Swap Stormwater Detention and Infiltration Design Data Sheet

Stormwater Facility Name: 18910 Base Camp Road

SDI_v1-redline.pdf Markup Summary

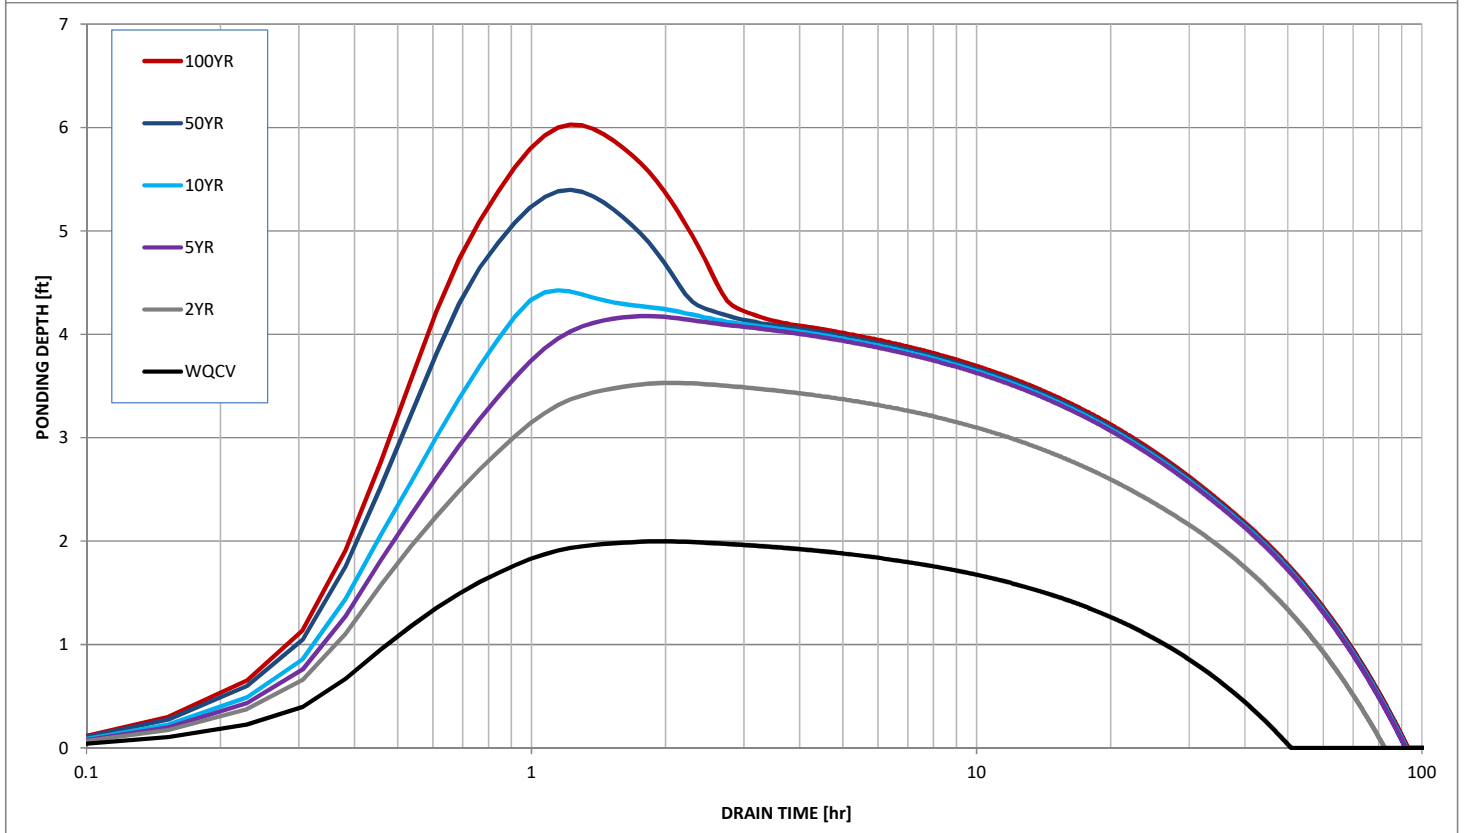
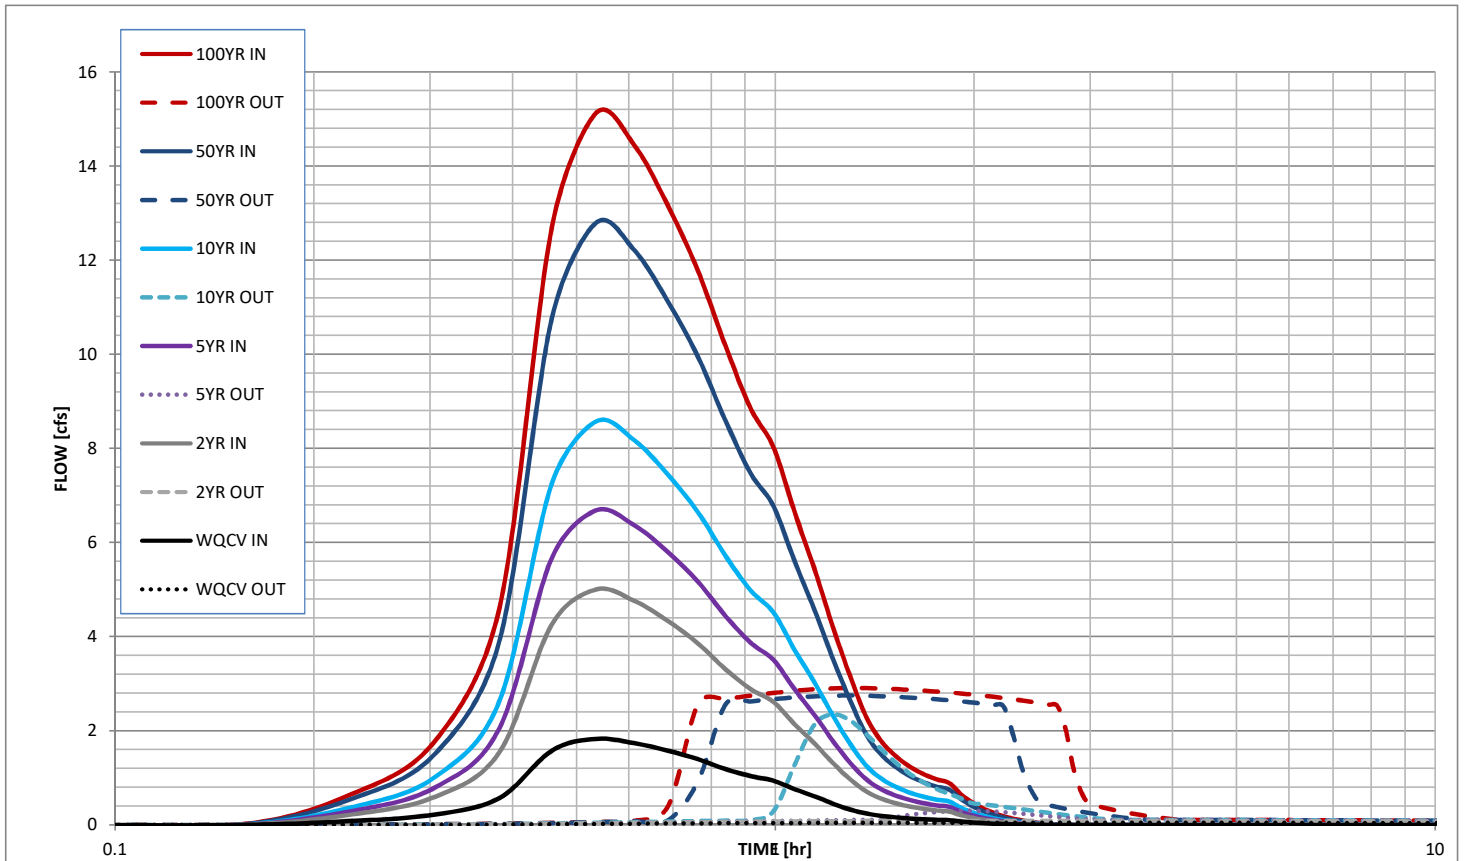
Add (PCD File No. PPR1919)

Include "El Paso County"

This must be within 72 hrs per Senate Bill 15-212
